## Notice of Product Discontinuance following Renewal of GTR-AR Battery-powered Type

### 1. Discontinued Products

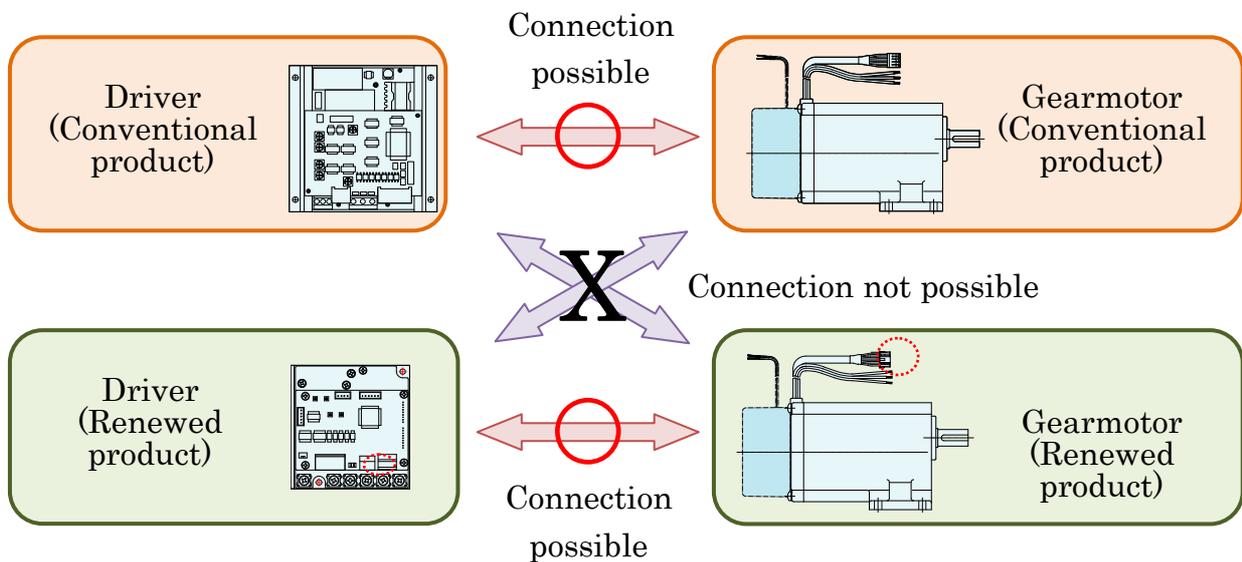
### <Differences between renewed gear motors and conventional gear motors>

- The connector specification for the signal wire sticking out of the motor section is different.
- The model is different. (An "A" is added to the end of the conventional model.)
- \* There are no changes to other specifications (external dimensions, performance, etc.). For details, please refer to the product's catalog.

Please note that the connector specification for the motor signal wire differs between the conventional and renewed products, and so they cannot be connected.

(Refer to figure.)
